Access Compliance Report

(Curb Ramps)

Intersection ID: 21533	Main Street: LENOX_POINTE_DR	Cross Street: KINGS_PARADE_BV	Location: E
ADA ID: 887D64C53D30	Ramp Type: Perp	Initial Pass/Fail: Fail	Overall Compliance: No
Severity Score: 21.25			
Codes/Mitigation Info/Possible Solution		Field Measurements/Component Compliance

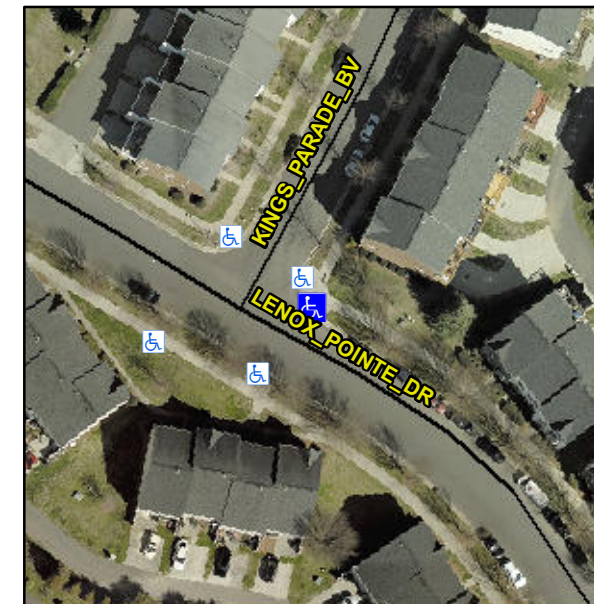
Not Found, R304.5.1, R304.2.2

Compliance	Description	Data	Compliance	Description	Data
N/A	Ramp Length (in)	76.0	No	Ramp Slope (%)	10.2
No	Ramp Width (in)	46.0	Yes	Ramp XSlope (%)	1.1
N/A	Flare Type LT	N/A	N/A	Flare Type RT	N/A
N/A	Flare Slope LT (%)	N/A	N/A	Flare Slope RT (%)	N/A
N/A	Flare Traversable LT?	N/A	N/A	Flare Traversable RT?	N/A
N/A	Landing Length (in)	N/A	N/A	DWS Provided?	N/A
N/A	Landing Width (in)	N/A	N/A	DWS Contrast?	N/A
N/A	Landing Slope (%)	N/A	N/A	DWS Length (in)	N/A
N/A	Landing X Slope (%)	N/A	N/A	DWS Full Width?	N/A
N/A	Landing Curb? (Y/N)	N/A	N/A	DWS Offset (in)	N/A
N/A	Shared Landing?	N/A			
N/A	Gutter Ponding?	N/A	N/A	Gutter Slope (%)	N/A
N/A	Gutter Lip Ht (in)	N/A	N/A	Gutter X Slope (%)	N/A
N/A	Painted X Walk1?	No	N/A	Painted X Walk2?	N/A
	X Walk 1 Direction	To SW		X Walk 2 Direction	N/A
N/A	X Walk 1 Width (in)	N/A	N/A	X Walk 2 Width (in)	N/A
	X Walk 1 Slope (%)	2.6		X Walk 2 Slope (%)	N/A
	X Walk 1 X Slope (%)	1.6		X Walk 2 X Slope (%)	N/A

Remove & Replace Entire Ramp.
